SUNDRY NOTICES AND REPORTS ON WELLS

Energen Resources would like to request additional changes to the drilling plans as follows. Verbal approval given by Dave Mankiewicz (BLM) on 11/2/15 @ 1:55 pm.

Chaco 23-08 3 #002H

Chaco 23-8 3 #2H - Revised

Revised Plan

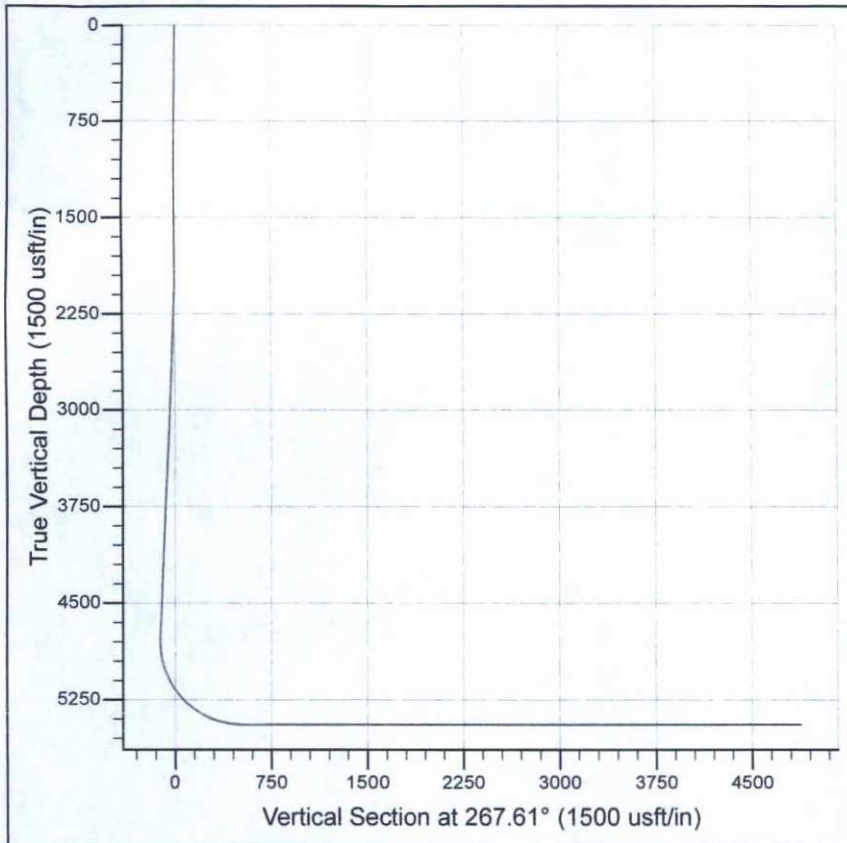
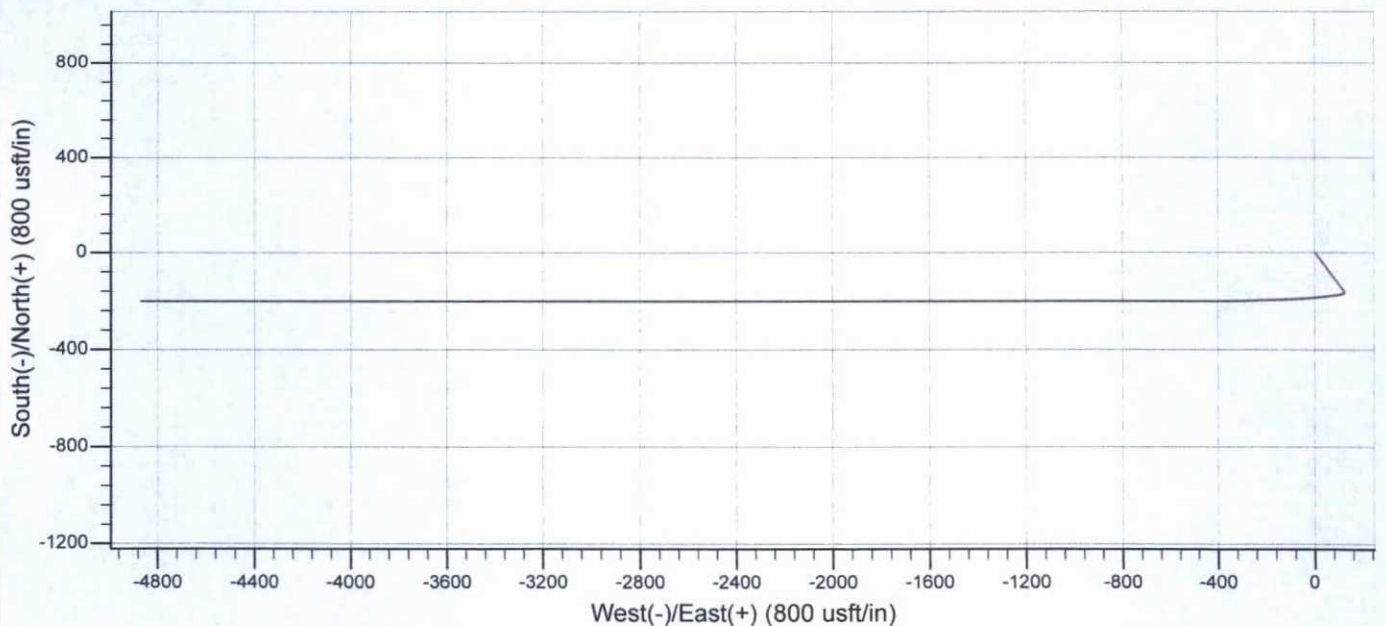
- 9.625" casing: Change the set depth from 500'MD to 320'MD and decrease cmt volumes to 190 sks. The standard bow spring centralizers shall be placed one (1) on the first joint, then two (2) more placed at Energen's discretion for a total of three (3) for the entire string.
- 7.0" casing: Change the set depth from 5900'MD to 5820'MD and increase cmt volumes to 720 sks followed with 95 sks.
- 4.50" casing: Change set depth from 5750'-9830'MD to 5620'-10179'MD and an increase of cmt volumes to 500 sks. Change hole size from 6.25" to 6.125".

Please see attached Directional/Drilling plans.
